# Access Compliance Report

## Public Rights-of-Way

### (Curb Ramps)

Intersection ID: 10350	Main Street: BANCROFT_ST	Cross Street: KESWICK_AV	Location: S
ADA ID: F0332CC0FAD1	Ramp Type: BlendTrans1	Initial Pass/Fail: Fail	Overall Compliance: No
		Severity Score: 10

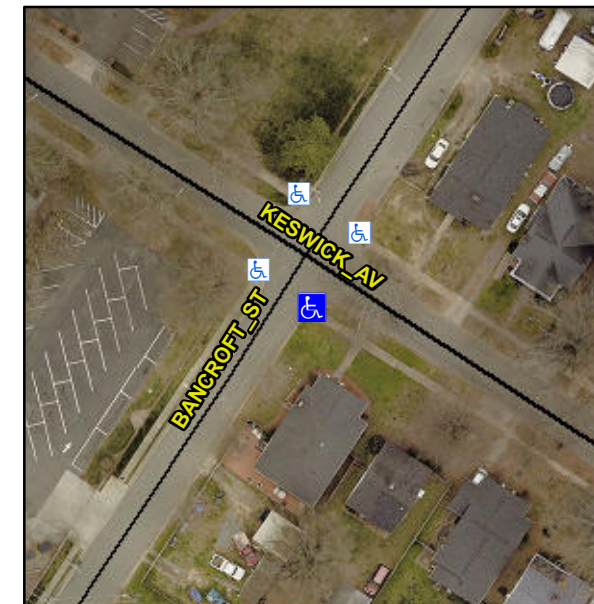
**Not Found, R304.5.1, R304.5.3**

Compliance	Description	Data	Compliance	Description	Data
N/A	Ramp Length (in)	50.5	Yes	BlendTrans Slope (%)	4.2
No	Ramp Width (in)	46.0	No	BlendTrans XSlope (%)	2.2
N/A	Flare Type LT	N/A	N/A	Flare Type RT	N/A
N/A	Flare Slope LT (%)	N/A	N/A	Flare Slope RT (%)	N/A
N/A	Flare Traversable LT?	N/A	N/A	Flare Traversable RT?	N/A
N/A	Landing Length (in)	N/A	N/A	DWS Provided?	N/A
N/A	Landing Width (in)	N/A	N/A	DWS Contrast?	N/A
N/A	Landing Slope (%)	N/A	N/A	DWS Length (in)	N/A
N/A	Landing X Slope (%)	N/A	N/A	DWS Full Width?	N/A
N/A	Landing Curb? (Y/N)	N/A	N/A	DWS Offset (in)	N/A
N/A	Shared Landing?	N/A			
N/A	Gutter Ponding?	N/A	N/A	Gutter Slope (%)	N/A
N/A	Gutter Lip Ht (in)	N/A	N/A	Gutter X Slope (%)	N/A
N/A	Painted X Walk1?	No	N/A	Painted X Walk2?	No
	X Walk 1 Direction	To NE		X Walk 2 Direction	To NW
	X Walk 1 Width (in)	N/A		X Walk 2 Width (in)	N/A
	X Walk 1 Slope (%)	3.3		X Walk 2 Slope (%)	3.5
	X Walk 1 X Slope (%)	1.5		X Walk 2 X Slope (%)	2.8

N/A	Ramp inside XWalk1?	N/A	N/A	Ramp inside XWalk2?	N/A
	Road Slope (%)	3.4		Clear Space?	N/A
	Road X Slope (%)	2.0	N/A	Clear Space to XWalk (in)	N/A
N/A	Any Obstructions?	N/A	N/A	Storm Grate/Utility Hazard?	N/A
	Obstruction Type			Storm Grate/Utility Type	
		N/A			N/A
			Yes	Surface Condition? (G/P)	Good
			No	Curb Slope (%)	12.5

**Remove & Replace Curb Ramp With Two New Directional Ramps or Equivalent.**
